**Waipawa Street for People**

**Preliminary Design Stage Safe System Audit Report**

**Prepared for Central Hawke's Bay District Council**

REVISION 0 – APRIL 2023

Figure 5.3-12 – Pedestrian demand across Kenilworth Street

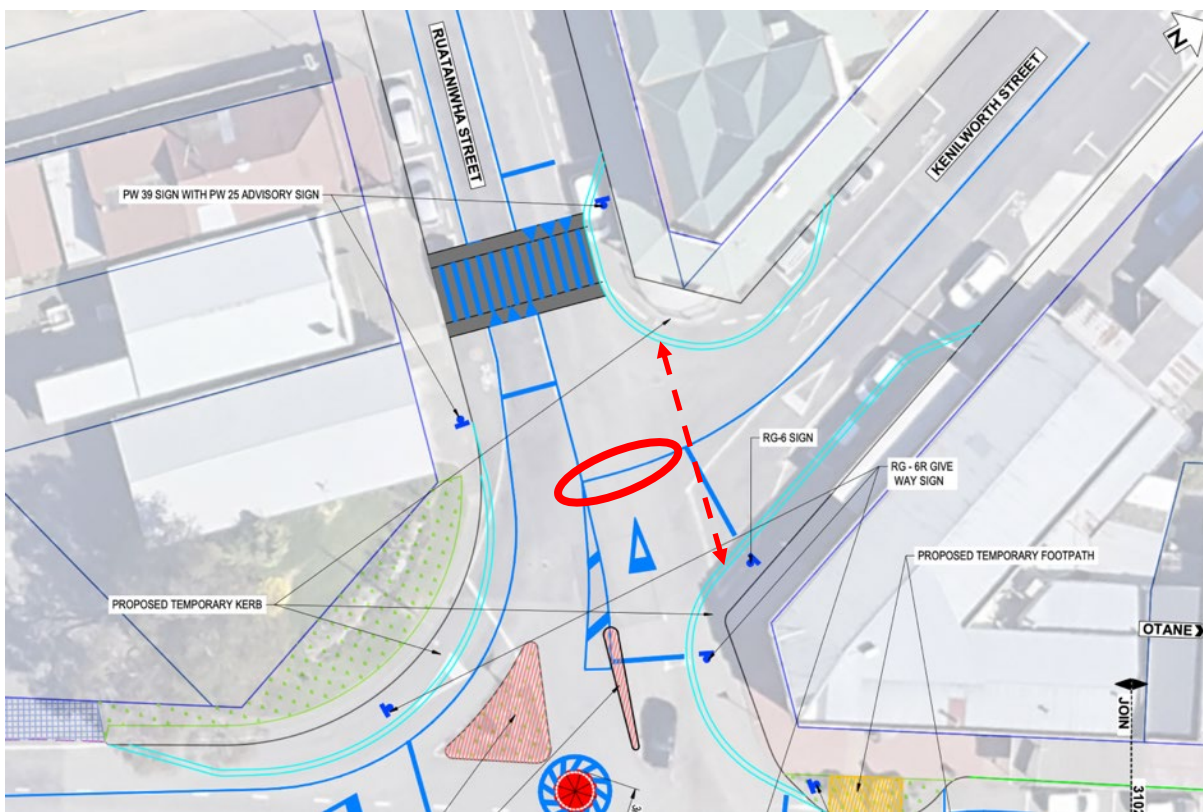
The design does not include any pedestrian facilities across Kenilworth Street. The SAT is aware of there being reasonable pedestrian demand across this intersection. The angle of entry of Kenilworth Street makes this a wide intersection for pedestrians to cross. There is a risk in particular to older, disabled and young vulnerable users trying to cross this wider section of road. Due the nature of the users any injuries will be serious.

Consideration should be given to providing improved pedestrian facilities across this intersection.

There is a non-standard line, circled in Figure 5.3.12, which is assumed to be a draughting error.

1. Consider improved pedestrian facilities across Kenilworth Street; and
2. Ensure road marking is as per standards.

**Figure 5.3-13 – Line marking adjacent to the kerb**

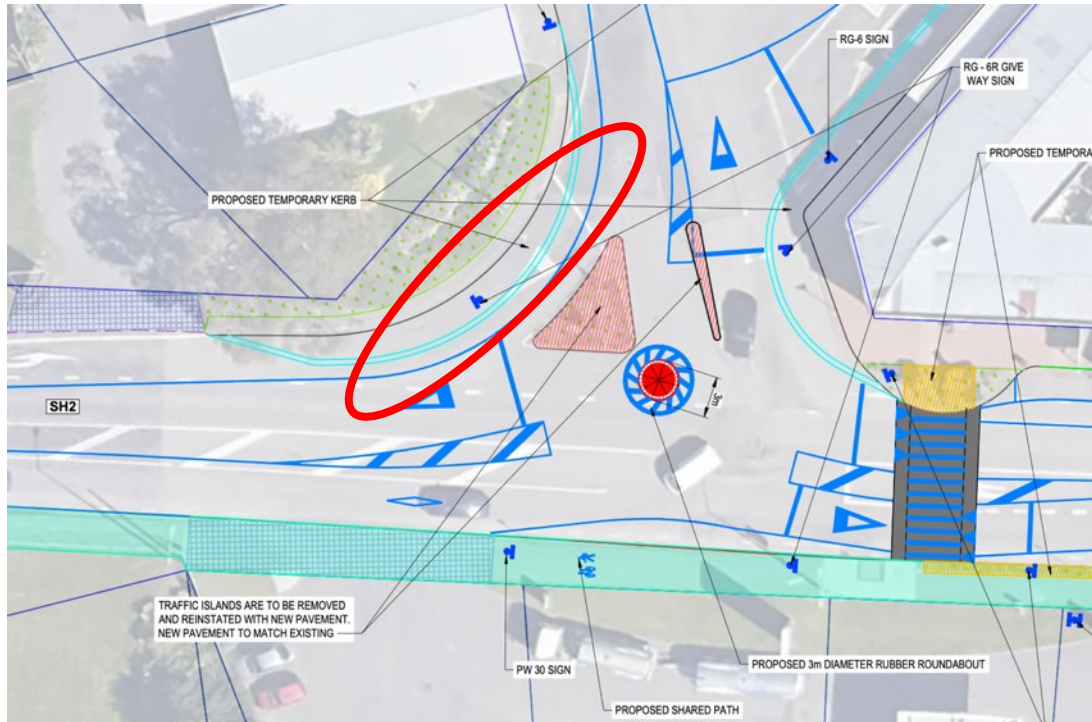
The design includes an edge line adjacent to the south-west corner of the roundabout. This is offset from the proposed kerb by a distance that may make cyclists have a false sense of security and utilise this space as a pseudo cycle lane. There is a high risk of cyclists being struck in this pinch point by heavy vehicles negotiating the roundabout. This is likely to result in death or serious injuries.

Consideration should be given to removing this line and/or extending the kerb out further if this is space not required for vehicle tracking.

1. Consider extending the kerb line or removing marking.
